The ISO received comments on the topics discussed at the September 25 and 26, 2019 stakeholder call from the following:

The following are the ISO's responses to the comments.

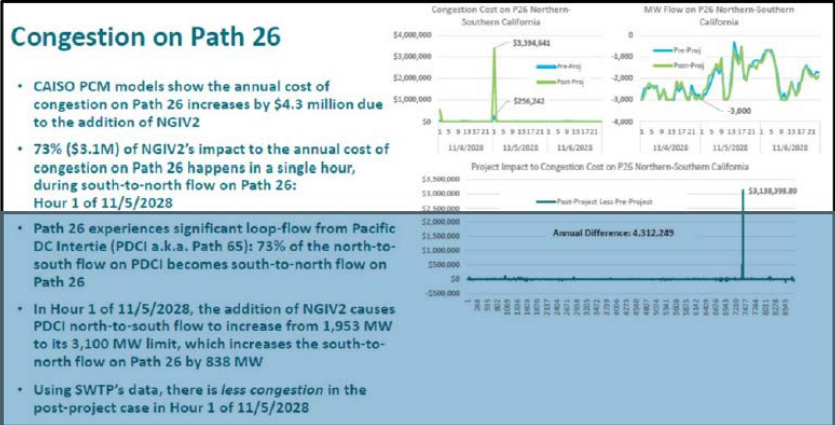
11b	<p><u>Analysis using 42 MMT Case</u> In the beginning of the 2019-20 TPP cycle, the CAISO published the new 42 MMT case in response to aggressive renewable goals set by CEC. The 2019/20 Base plan as proposed and presented has a base case statewide electric sector GHG reduction target of 42 million metric tons (MMT) by 2030 as set forth in Senate Bill (SB) 350. Using the 42MMT case published by the ISO from the 2018-19 transmission plan, NEER has performed a Production Cost Model (PCM) Analysis using GridView the same tool used by CAISO to</p>	<p>The comment has been noted.</p>
